Monticello Nuclear Generating Plant  
2807 West County Road 75  
Monticello, MN 55362-9637

MONTICELLO NUCLEAR GENERATING PLANT  
Docket No. 50-263 License No. DPR-22

License Amendment Request  
Main Condenser Offgas Technical Specification Change

FIGURE 1. MONTICELLO GASEOUS RADWASTE TREATMENT SYSTEM,  
CURRENT CONFIGURATION

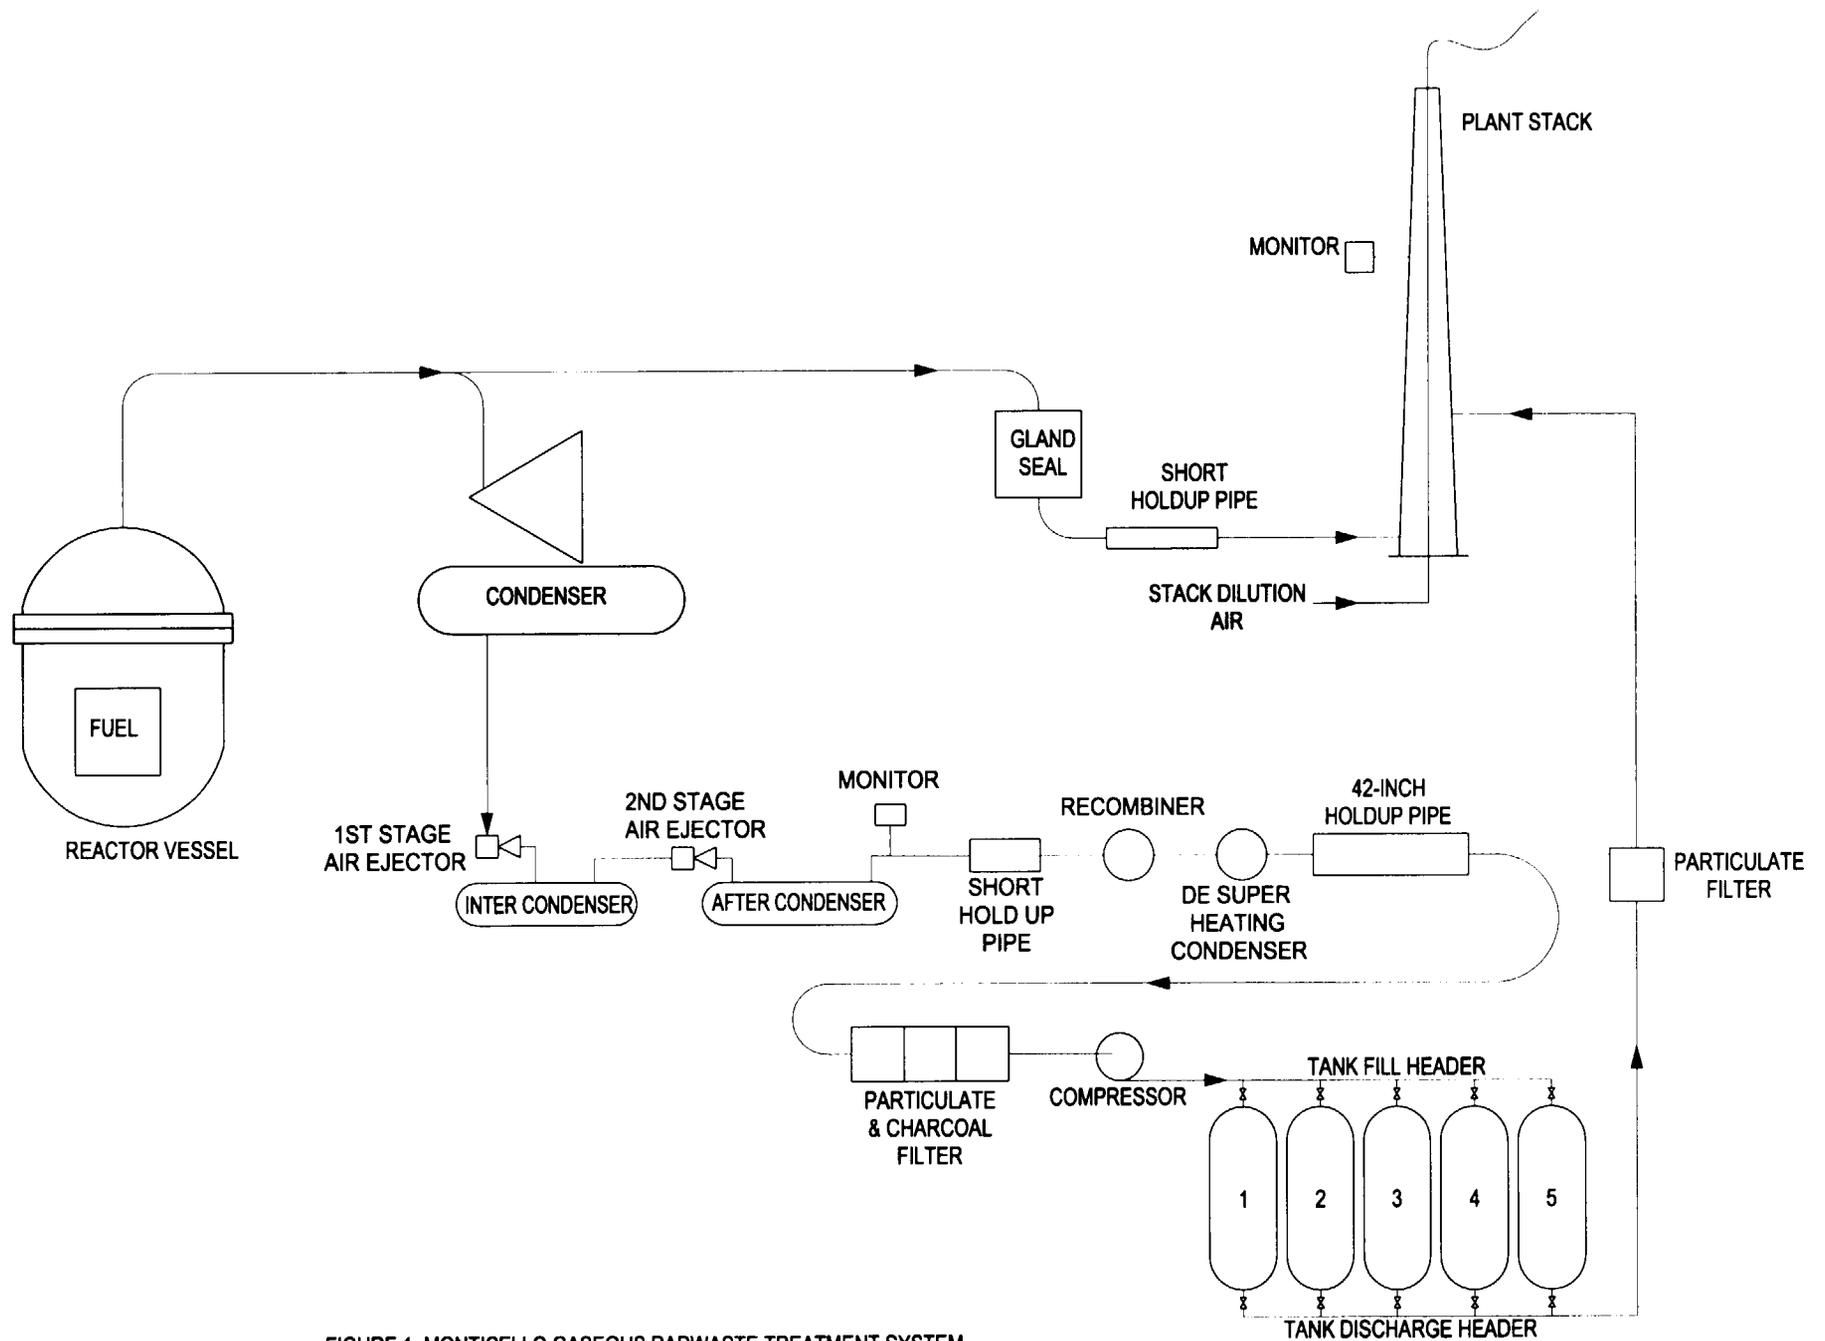
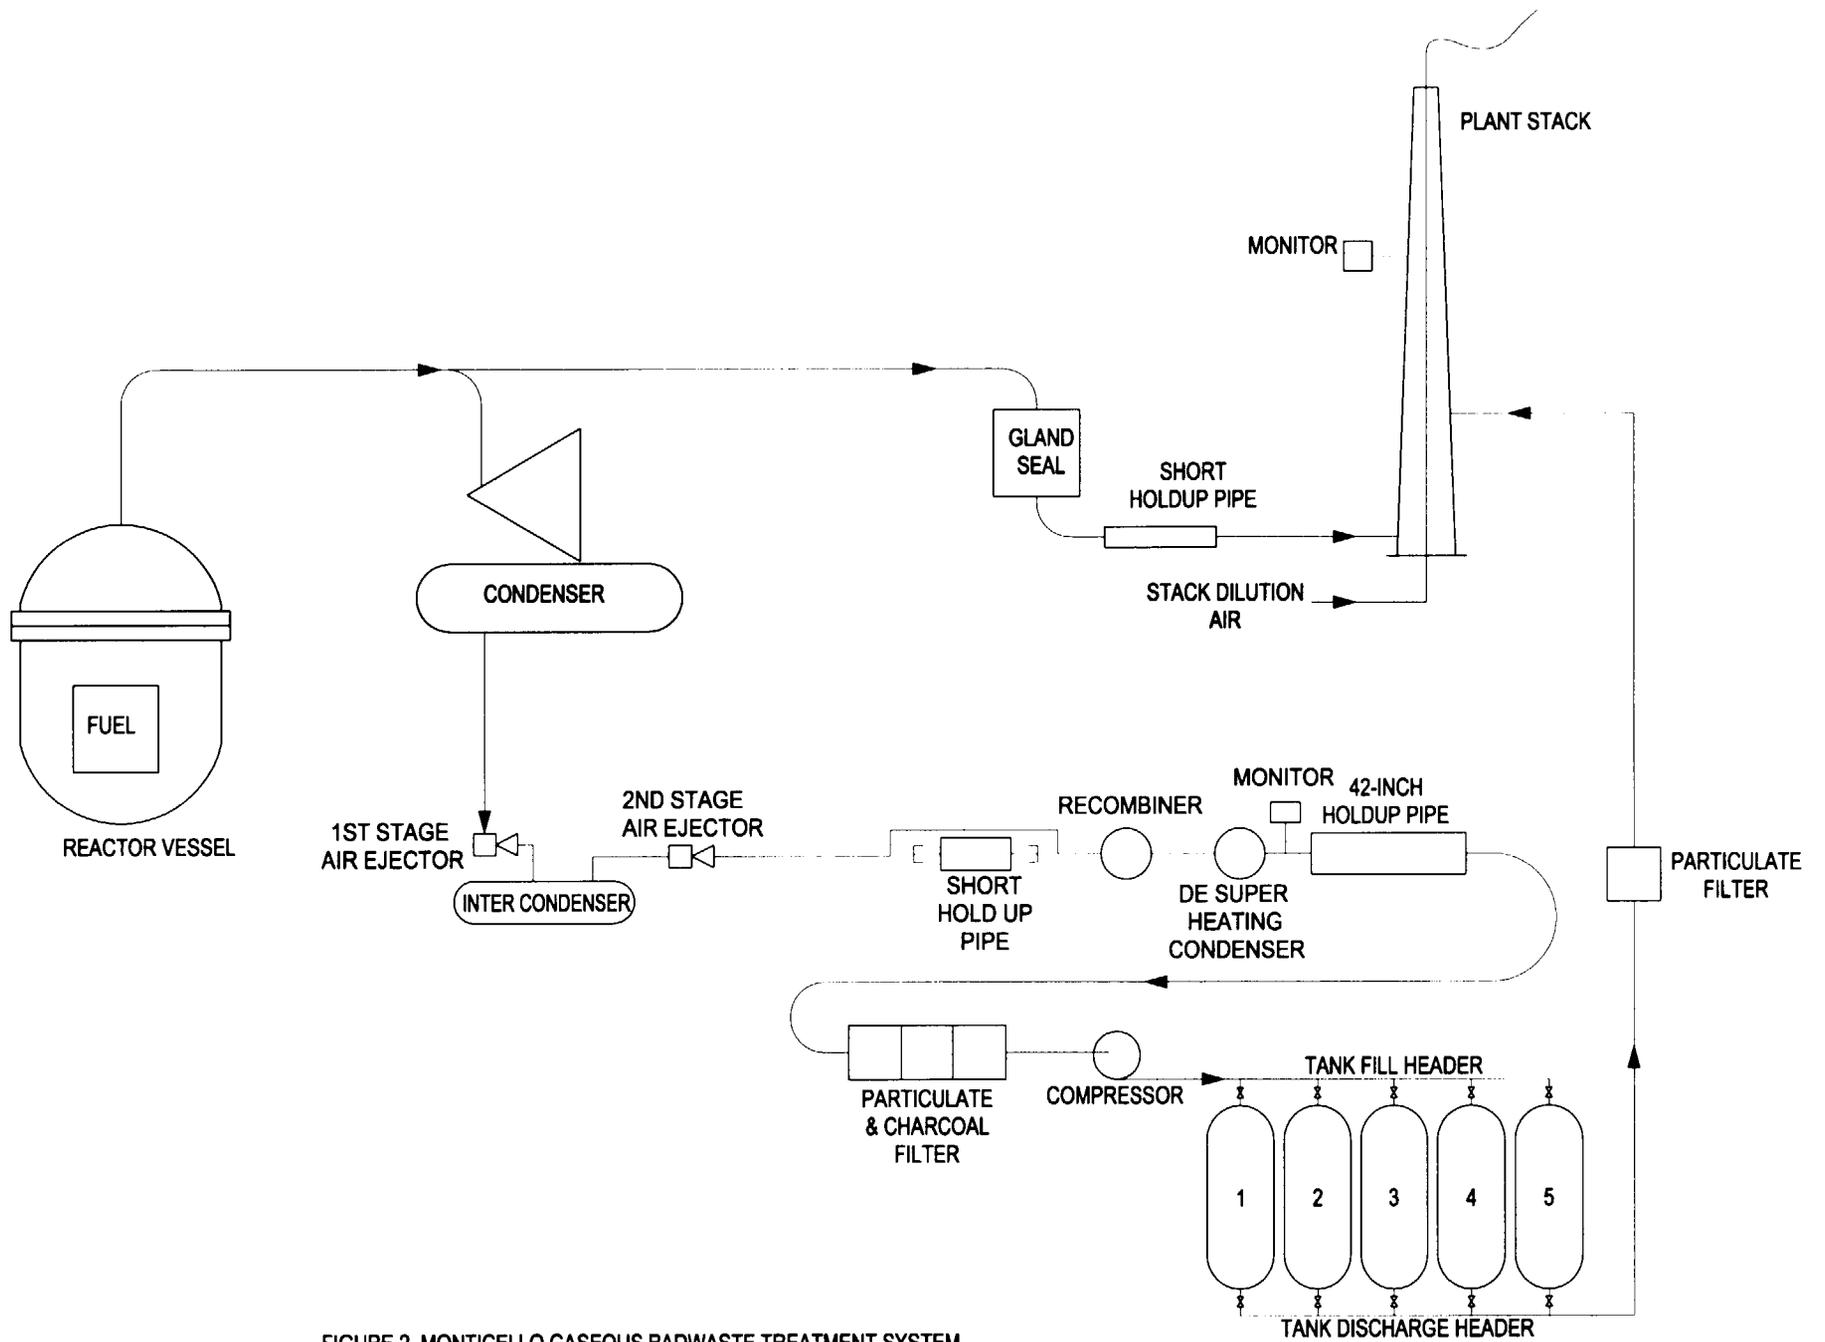
Currently, main condenser offgas activity is measured at the outlet of steam jet air ejector (SJAE) after condensers. A modification is planned to convert the offgas system to a full steam dilution system to eliminate the potential for explosive mixtures in the line to the offgas recombiners. Following the modification, the process stream temperature and humidity will not allow sampling at the outlet of the SJAEs. As a

result, the main condenser offgas radiation monitors will be relocated to downstream of the recombiners prior to entering the holdup line.

2. Currently, the condenser offgas activity is measured at the outlet of the SJAEs as shown in Figure 1 attached. Monticello intends to install a full steam dilution system in the offgas treatment system to eliminate the possibility of an explosive

gas mixture in the line to the offgas recombiners. Following the modification, the process stream temperature and humidity will not allow sampling at the outlet of the SJAEs. As a result, the monitor point will be moved to downstream of the recombiners. A schematic of the modified system is shown in Figure 2 attached.

The intent of Technical Specification 3.8.A.1 is to monitor effluent from the main condenser SJAEs. However, the current wording states that effluent will be monitored *at* the SJAEs. The current system configuration was provided to NRC in a sketch (similar to Figure 1 attached to this exhibit) which was subsequently attached to the NRC letter (Reference 3) approving Amendment 15 to the Monticello operating license. Amendment 15 implemented the current SJAЕ monitoring requirements. Therefore, it is appropriate to revise the Specification 3.8.A.1 nomenclature with respect to the sampling point. The proposed wording for the revised specification is based on similar wording in the Reference 2 STS.

The future sample location will be consistent with the configuration of several other plants, such as the STS model plant. Additionally, a General Electric Service Information Letter (SIL) (Reference 4) recommends relocating the pretreatment radiation monitors from the outlet of the SJAEs to downstream of the recombiners. The SIL notes that this will change the pretreatment calibration.

The setpoints and calculations will be revised as necessary to account for sample concentration and location changes. Detector sensitivity, accuracy, range, and other appropriate attributes, as well as delay time, will be considered to ensure that the revised setpoints and calculations maintain releases of main condenser offgas radionuclides within the release rate of Specification 3.8.A.1.

The future sample point does not allow any unmonitored release paths, since there are no bypass flow paths. Any effluent is either sent to the holdup portion of the system past the monitor point or is returned to the main condenser. Changing the description of the sample point will allow installation of the modification without a future technical specification change.
